## **CARES Notification**

**Subject: Expo Wheel Set-Up Bracket Ride(s) affected: Wadkins Expo Wheel**

Date: February 11, 2017

**Source: Florida Department of Agriculture and Consumer Services**

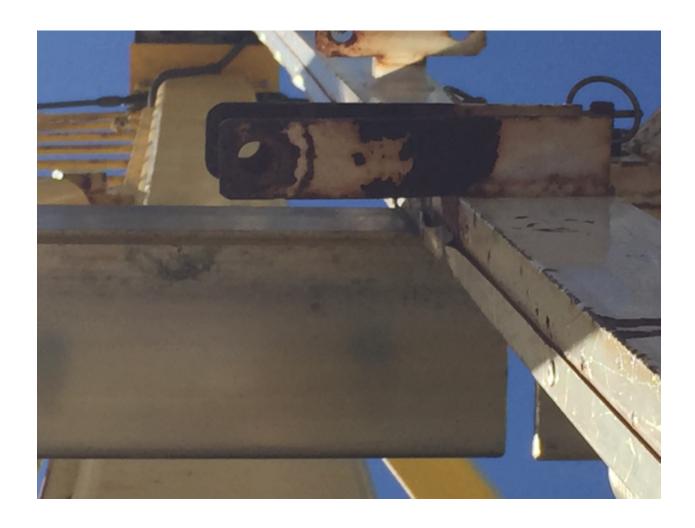
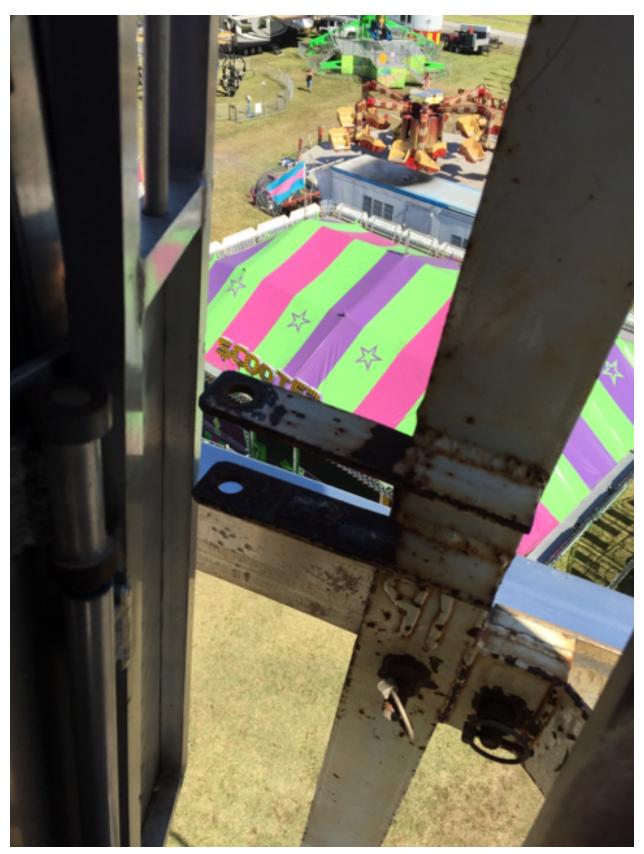
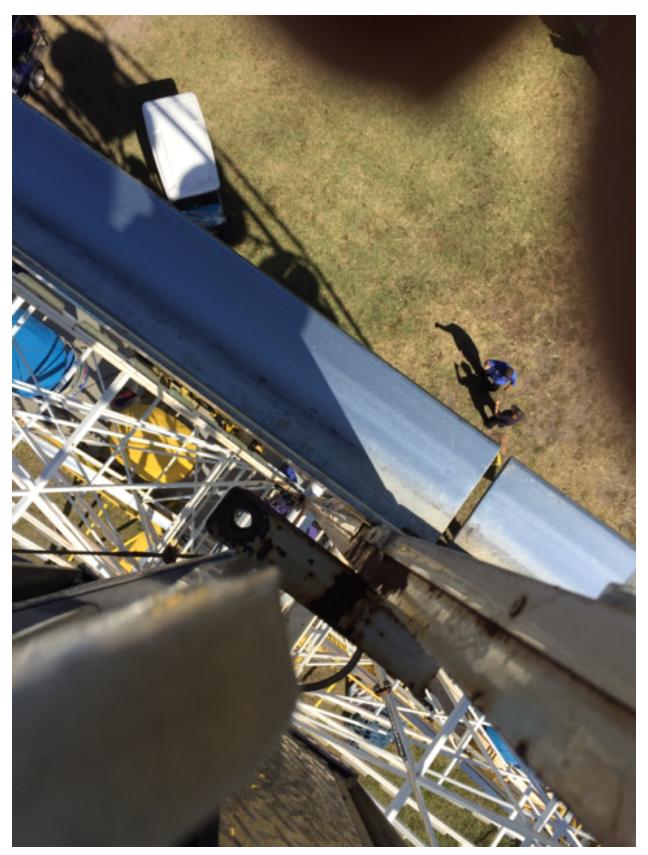
An inspector was dispatched to the site Saturday and completed an inspection of the device. During the inspection he and the owner's representative rode in the carrier involved and found that there were no restrictions as described during Friday night, but once they opened the carrier door it made contact with spoke #16 at the twelve o'clock position. It was found that with the carrier door opened it would contact a plate, welded to the spoke by the manufacturer that is used for tear down and assembly of the ride. The Bureau was in contact with the manufacturer over the weekend who required the doors of the carrier involved to be tied off from use. The inspector also issued an out of service tag on the affected carrier.

This letter is to give authorization to Mr. Billy Tucker, to modify the #16 spoke on the Expo Wheel. It has been brought to our attention, that the plates welded to spoke #16, that are only used during tear down and set up of the ride to hold the spoke cradle, can contact with the seat door if opened while passing the plates while operating the wheel. This can cause an unsafe condition by holding the seat in a fixed position and not allowing a full revolution of the seat. After evaluating the information given in phone calls, we feel that the plates need to be permanently removed and a removable bolt on unit be used in its place instead. Mr. Tucker is authorized to make these modifications on site, by cutting the plates off of spoke #16 and Wadkins Expo Wheel will ship the replacement parts to be used in the place of the plates being removed, to correct the issue. Until the plates are removed, it is recommended that seat #16 not be used and the doors be secured together with wire ties to prevent opening of the doors by the operator.

A letter from the manufacturer was received giving the owner approval to remove the plates from spoke #16 and a removal bolt be added in its place. The Florida Department of Agriculture and Consumer Services was informed by the manufacturer that all Expo Wheels built since 2011 were designed with a bolt-on set-up bracket which is to be removed after the ride is set up. The Bureau has instructed all of its inspectors to make sure that the set-up bracket has been removed from all Expo Wheels and has instructed that under no circumstances is an Expo Wheel permitted to operate with the set-up bracket installed.
